ADDRESS . . : 238 BASKET OAK DR
CONTRACTOR : H & H CONSTRUCTORS INC
OWNER . . . : WOODSHIRE PARTNERS LLC
PARCEL . . . : 01-0536-05- -0028- -05-
APPL NUMBER: 08-50021398 CP NEW RESIDENTIAL (SFD)
DIRECTIONS : HWY 27 TO NURSERY RD TUIRN LEFT ON
NURSERY RD LEFT ON LEMUEL BLACK RD LEFT
ON VALLEY OAK INTO FOREST OAKS S/D LOT
118 ON BASKET DR JB

Harnett County Inspection Department

Violations Found: 1) AOB Truss missing web bracing

Re: 298690
118 Forest Oaks, Harnett Co., NC

Job 298590	Truss F02	Truss Type FLOOR	Qty 5	Ply 1	118 Forest Oaks, Hamett Co., NC 15205748 Job Reference (optional) 1 UNIT YF
---------------	--------------	---------------------	----------	----------	--

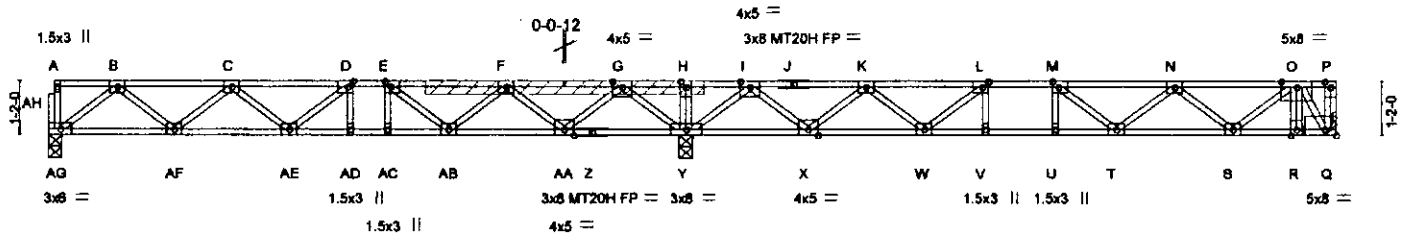
3) Need engineer repair letter for notched truss above kitchen for water line.

3/4" WIDE, 3/16" DEEP NOTCH IN TOP CHORD IN THE MIDDLE OF PANEL F-G

APPLY 2X4X6" SPF No.2 SCAB TO ONE FACE OF TRUSS CENTERED ON NOTCH.
ATTACH WITH CONSTRUCTION QUALITY ADHESIVE AND 1 ROW OF 10d (3" X 0.131") NAILS
SPACED 0-3-0 O.C. IN ALL ALIGNING MEMBERS. USE A MIN. 0-3-0 MEMBER END DISTANCE.
